UNITED STATES PATENT AND TRADEMARK OFFICE

APPLICATION NO.	FILING DATE	FIRST NAMED INVENTOR	ATTORNEY DOCKET NO.	CONFIRMATION NO.
10/580,211	05/23/2006	Yoshiki Tsuchiyama	1919.1009	1850
21171	7590	03/25/2008		
STAAS & HALSEY LLP SUITE 700 1201 NEW YORK AVENUE, N.W. WASHINGTON, DC 20005			EXAMINER SEVERSON, JEREMY R	
			ART UNIT 3653	PAPER NUMBER
			MAIL DATE 03/25/2008	DELIVERY MODE PAPER

Office Action Summary

DETAILED ACTION

FIG. 12

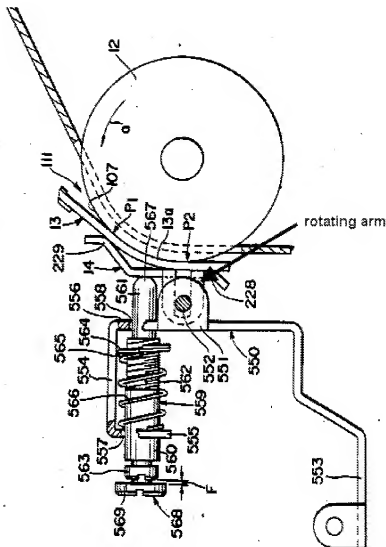
Re claim 1, Murayoshi discloses an automatic paper feeder supplying paper to an apparatus such as a printer or a scanner, comprising: a separation pad 13, pressing the paper against a pick roller 12 so as to feed the paper one by one; and pad pressing means 14, applying pressure to the separation pad so as to press the separation pad against a surface of the pick roller, wherein the pad pressing means is formed in a

reverse U-shape so that the separation pad is arranged such as to be pressed at two front and rear portions thereof against the surface of the pick roller, and wherein the pad pressing means is structured to be rotatable back and forth with respect to a rotating direction of the pick roller about a fulcrum 552 where pressure is applied to the pad pressing means. See fig. 12 and col. 17, lines 63 et seq.

Re claim 2, Murayoshi discloses the automatic paper feeder according to claim 1, further comprising: a rotating arm arranged so that the entire pad pressing means is rotatable about a predetermined position.

Re claim 3, Murayoshi discloses the automatic paper feeder according to claim 1 or 2, wherein the fulcrum where the pressure is applied to the pad pressing means is arranged such as to be movable back and forth depending on a type of paper which is fed. The movement of bracket 550 causes movement of fulcrum 552. See col. 18, lines 3-7.
